Groundwater Application Review Summary Form

Application # G- 19269

GW Reviewer: Mitra Khadka/Travis Brown Date Review Completed: 07/05/2023

G-19269 Mayfield Farms

Well to Well Interference – Theis (1935) Drawdown analysis at MARI 68801

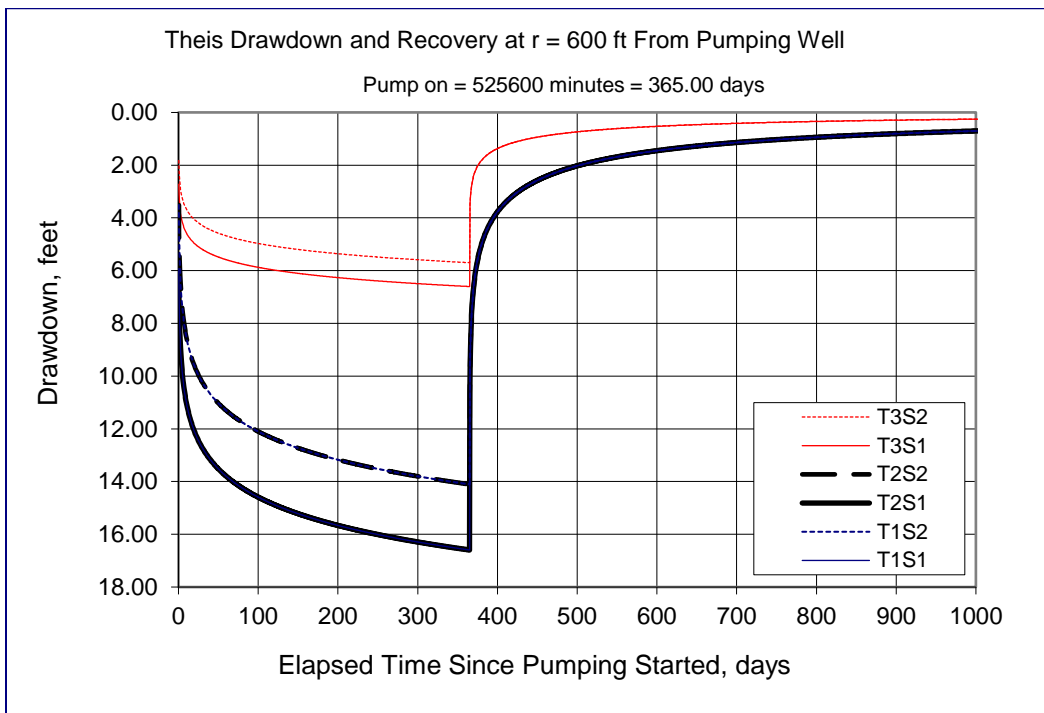
The nearest CRBG well to the proposed POAs is an exempt use domestic well MARI 68801, located about 600 ft west to the proposed Well 1 (MARI 69206). Interference with MARI 68801 was quantitatively estimated using a Theis (1935) time-drawdown model for a confined aquifer. Hydraulic parameters used for the analysis were derived from regional data and studies (Pumping Test Reports; Conlon et al., 2005; McFarland and Morgan, 1996). The analysis estimates maximum drawdown to be less than 16 ft in MARI 68801 after 365 days of continuous pumping at the maximum requested rate (see attached Well to Well Interference). Under the standard condition for basalt aquifers in the Willamette Basin, Condition 7i,

the requested use would need to be curtailed if hydraulic interference exceeded 15 ft in any neighboring well providing senior exempt uses or covered by prior rights. However, given the fact that the MARI 68801 is completed to a depth of 286 ft and does not fully penetrate the CRBG, the proposed use of groundwater is unlikely to cause Substantial and Undue Interference with the neighboring well.
